**Planning Commission  
Staff Report**

May 13, 2015  
Item 6.c.

- SUBJECT:** P15-0170/PUD-81-30-89D/P15-0169/PUD-81-30-55M
- APPLICANT/  
PROPERTY OWNER:** SummerHill Housing Group
- PURPOSE:** Applications for the following at the approximately 5.9-acre site: (1) Planned Unit Development (PUD) Major Modification to City Council Ordinance No. 2030 to modify the minimum density requirement of 30 dwelling units/acre to a density of 15.9 dwelling units/acre; (2) an amendment to the Housing Site Development Standards and Design Guidelines to modify the minimum and maximum density requirement of 30 dwelling units/acre to a minimum and maximum density of 15.9 dwelling units/acre; (3) PUD Development Plan to construct 94 residential condominium units and related site improvements; and (4) an amendment to the Development Agreement for the project.

- GENERAL PLAN:** Mixed Use/Business Park
- ZONING:** Planned Unit Development – Mixed Use (PUD-MU)
- LOCATION:** 5850 West Las Positas Boulevard
- EXHIBITS:**

**Figure 2: Proposed Site Plan**

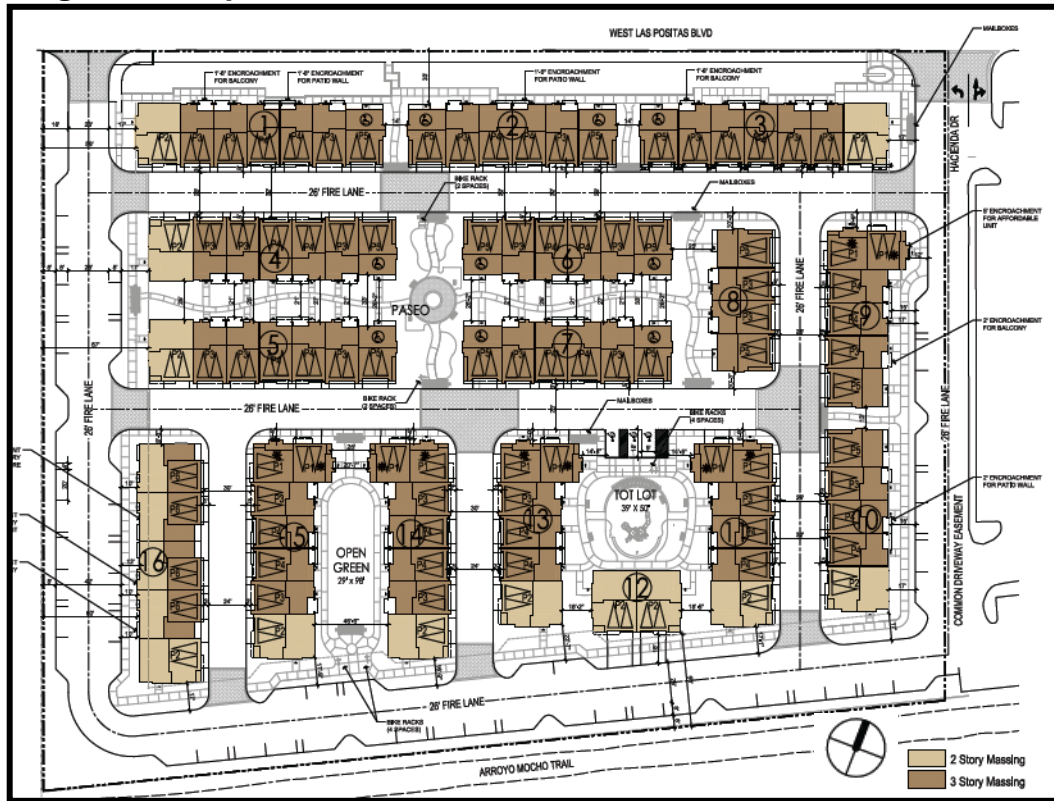
1. Front Yard Setback (*page 20, Design Guideline A4.2.*) – *Front setbacks shall be a minimum 8 feet from the back of sidewalk providing enough room for planting and privacy while still allowing a strong relationship between the units and street.*

Buildings 9 and 16 would not comply with the front yard setback requirements in the Standards and Guidelines. Specifically, the northern end of Building 9 would be located 4'-6" from the back of the sidewalk, and the eastern end of Building 9 would be located 7' from the back of the sidewalk. Building 16 would be located 5' from the back of the sidewalk.

Comments: The front yard exception is requested for Buildings 9 and 16 fronting internal streets. The northern end of Building 9 would be located 9'-6" from the face of curb on the north side and 12 feet from the face of the curb on the east side. Building 16 would be located 10 feet from the face of curb. Staff finds that proposed setbacks would provide enough separation between the units and the street. Therefore, staff can support this exception.

2. Building Orientation (*page 14, Design Guidelines A2.c*) – *On residential frontage including public streets, internal streets, pedestrian walks/paseos, and open spaces, a minimum of 75% of building façade should be fronted with livable residential space, i.e. not garages.*

Building 12 has garages fronting the street and do not meet the 75% requirement.

Comments: Building 12 is a two-story, two-unit building. Given that it is a two-unit building contains only two garages, and given that the remaining buildings along this street meet this building orientation requirement, staff is able to support this exception.

3. Building Separation (*page 23, Standard A6.1 Paseo*) -- *A 25-30 foot minimum building-to-building separation is required for residential buildings along paseos.*

Comment: Buildings 4 through 7 face a paseo. As the building walls are alternately recessed and projected, the walls of the middle two units of Buildings 4 and 5 would have a 21-foot separation. A similar situation occurs at Buildings 6 and 7. The areas that need the exception are located on the upper level of the buildings and the amount of encroaching building is limited (approximately 12% of Buildings 4 and 5 and approximately 14% of Buildings 6 and 7). In addition, the spacious central

paseo area provides a usable space for residents, thus compensating for the small portions of the buildings which do not meet the minimum building-to-building separation requirements. Therefore, staff supports this exception.

4. Planter Strips (*page 20, Standard A4.1 Internal Street*) -- *A minimum four-foot planting strip is required on each of the street.*

The proposed site does not include a planting strip on the west side of Building 16 or the northern end of Building 9.

Comment: An open space area is proposed between Buildings 14 and 15. The elimination of the planting strip on the west side of Building 16 helps to maximize the open space area. Staff finds this an acceptable tradeoff. Except at the northeastern corner of Building 9, a planting strip is proposed along the east side of the building and the street. Staff finds it acceptable for this small area to deviate from the standard. Therefore, staff supports this exception.
